CASE NO. FP-2026-0004

ORDER OF CONDITIONAL
APPROVAL OF FINAL PLAT

STAFF REPORT

SUBJECT: Dayspring Subdivision No. 2
FP-2026-0004

B. Final Plat (dated: 2/10/26)

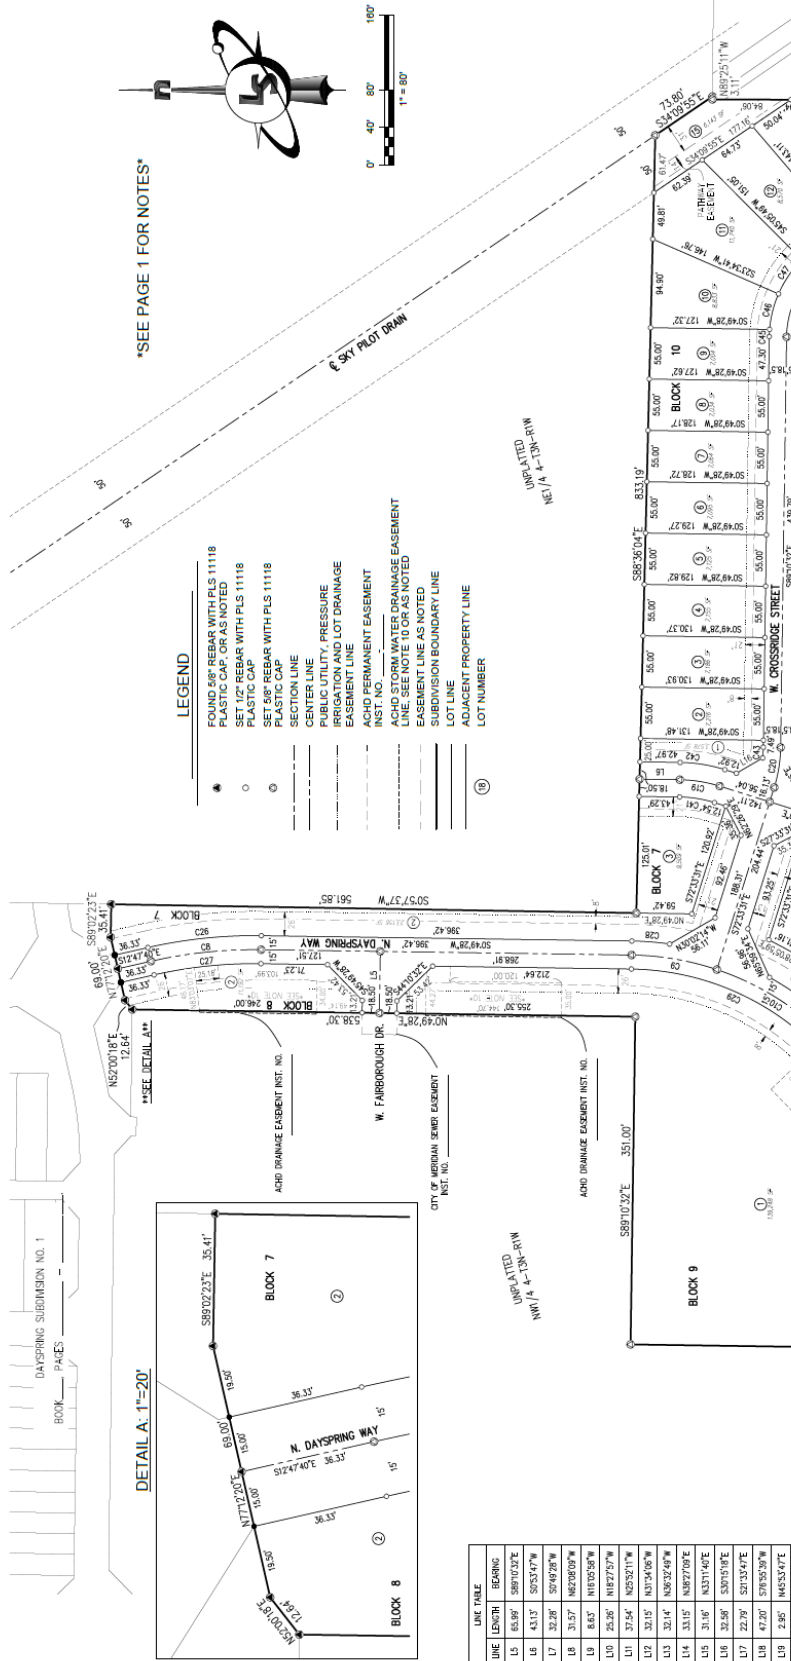
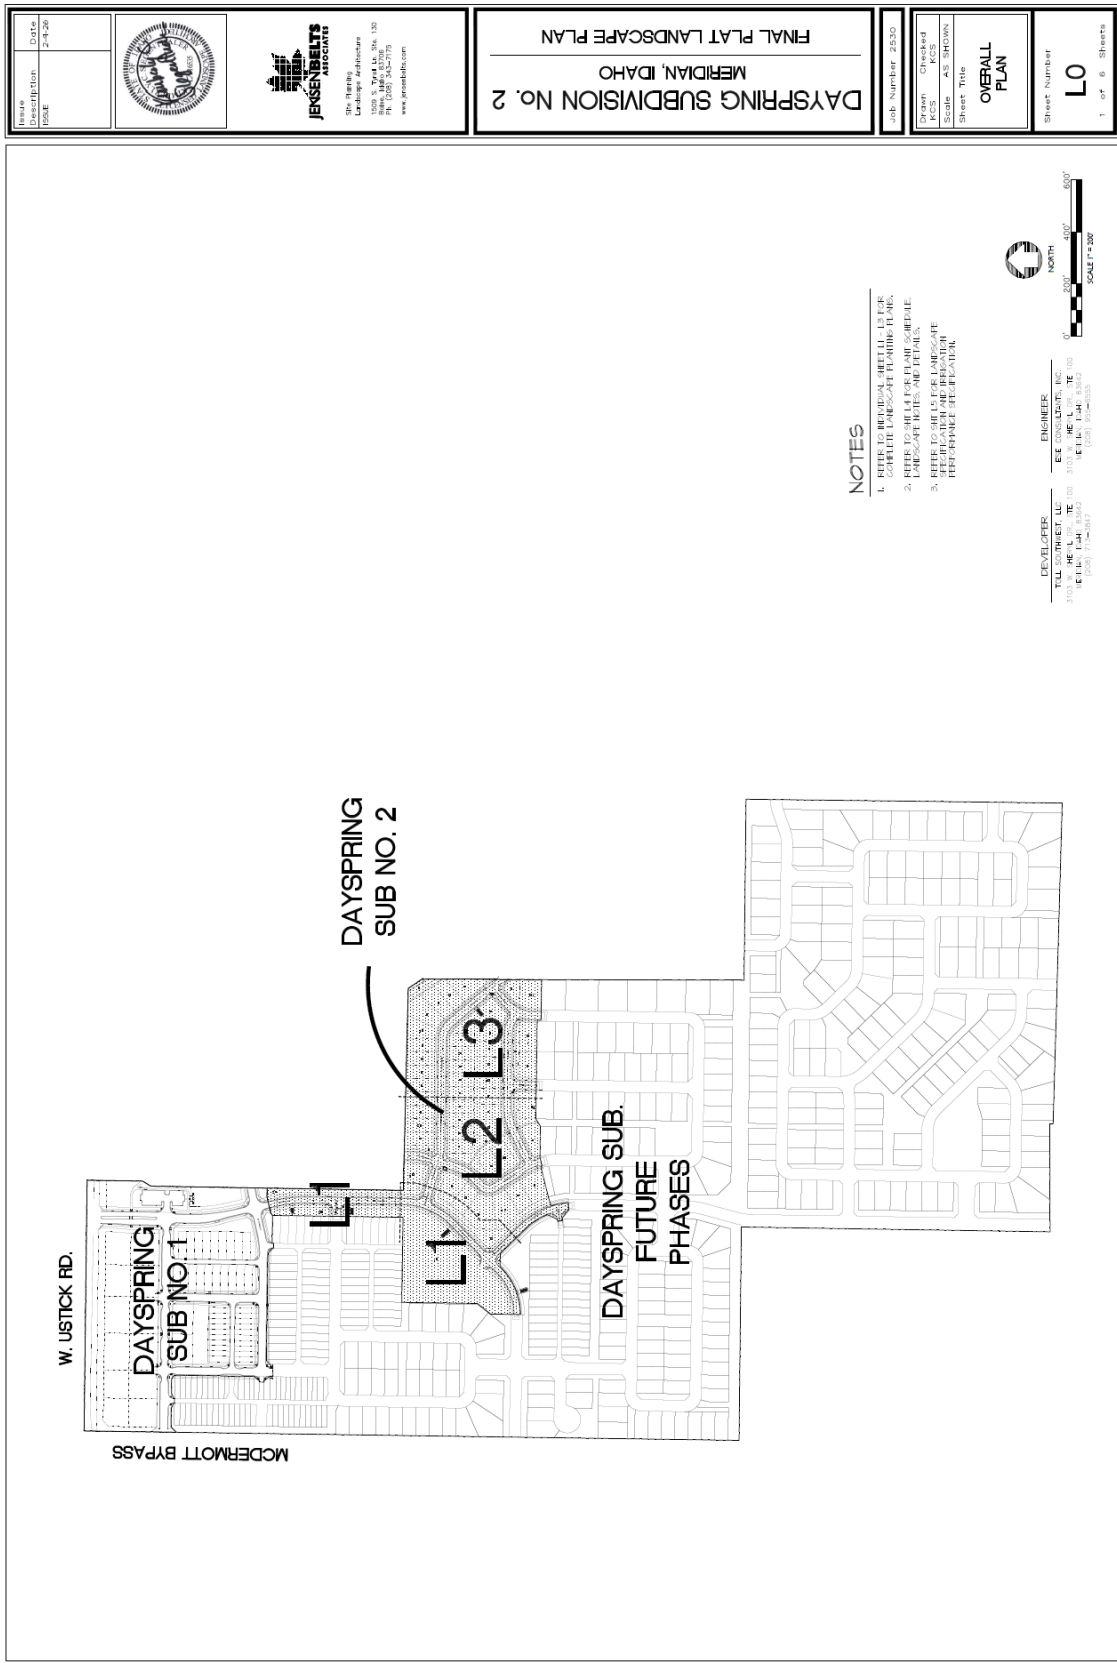
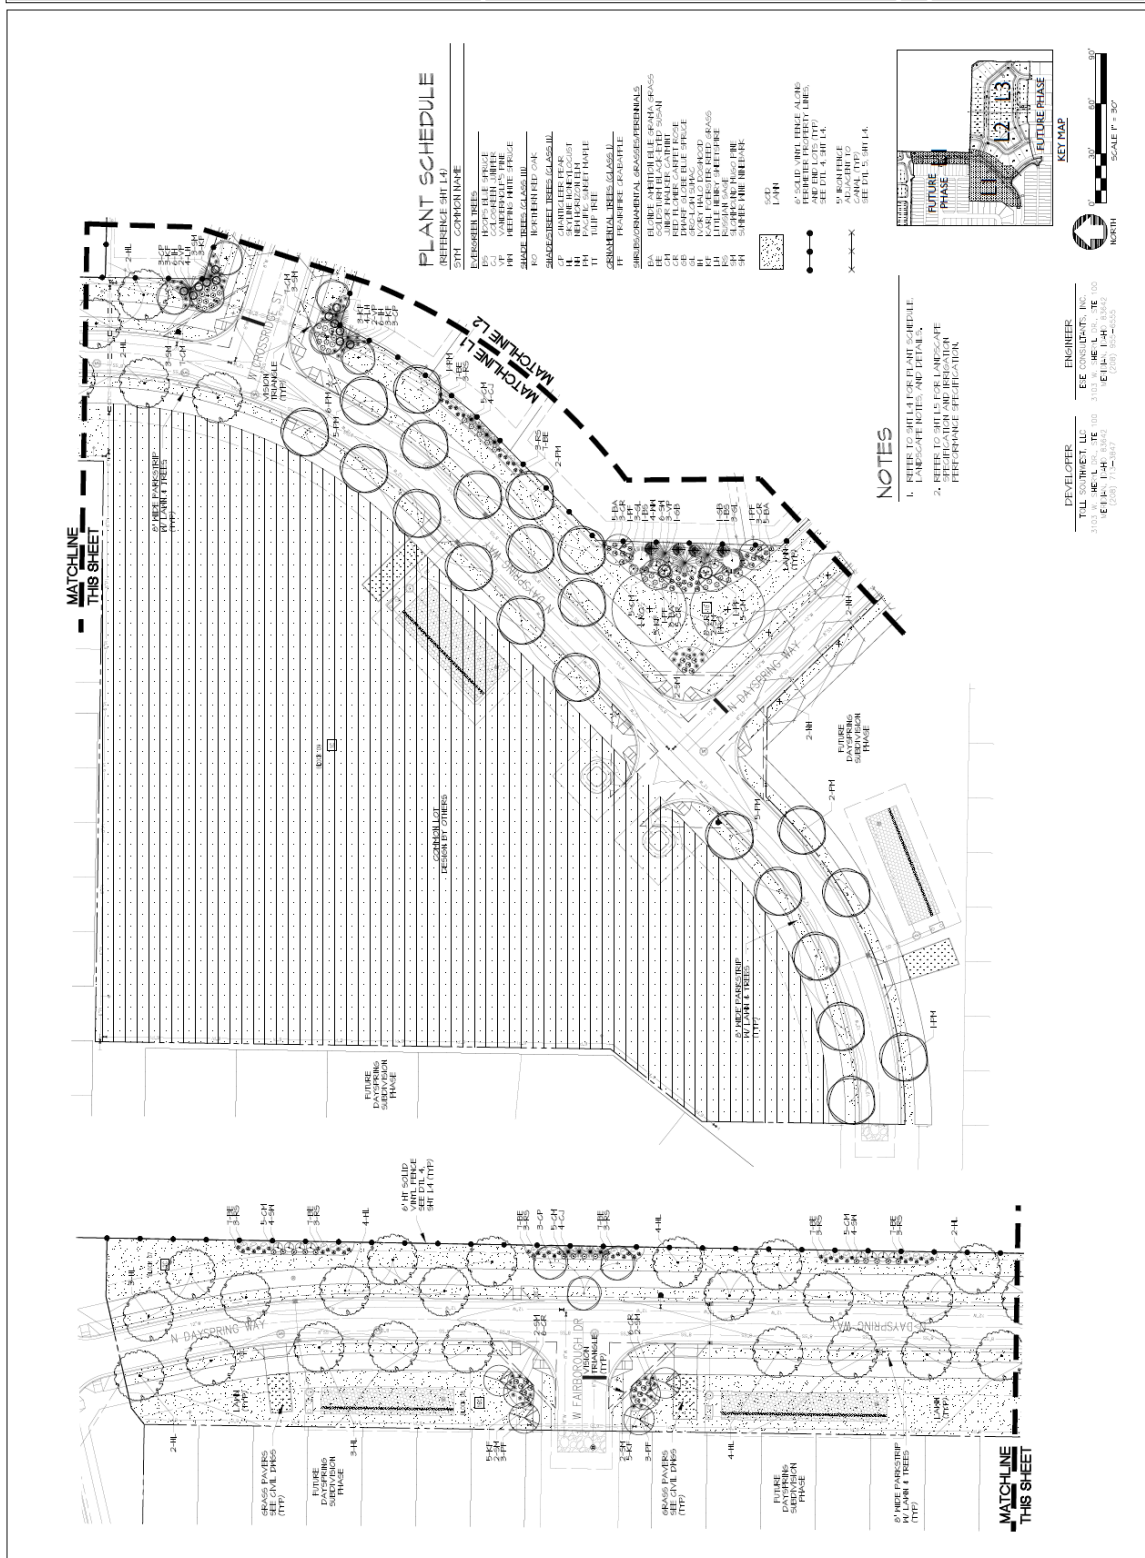
3. Prior to submittal for the City Engineer's signature, have the Certificate of Owners and the accompanying acknowledgement signed and notarized.
4. The final plat prepared by Clinton W. Hansen, Land Solutions Land Surveying and Consulting, dated: 2/10/2026, included in Section V.B shall be revised as follows:

- a. Include the Book and Page numbers for Dayspring Subdivision No. 1.
 - b. Legend: Include the recorded instrument number of the ACHD permanent easement.

- c. Include the recorded instrument number of the ACHD drainage easement.
 - d. Include the recorded instrument number of the City of Meridian sewer easement.

- e. Note #9: Include the recorded instrument number for the development agreement (i.e. #2026-007562).
 - f. Note #11: Include the recorded instrument number of the ACHD temporary license agreement.

A copy of the revised plat shall be submitted with the final plat mylar signature application.
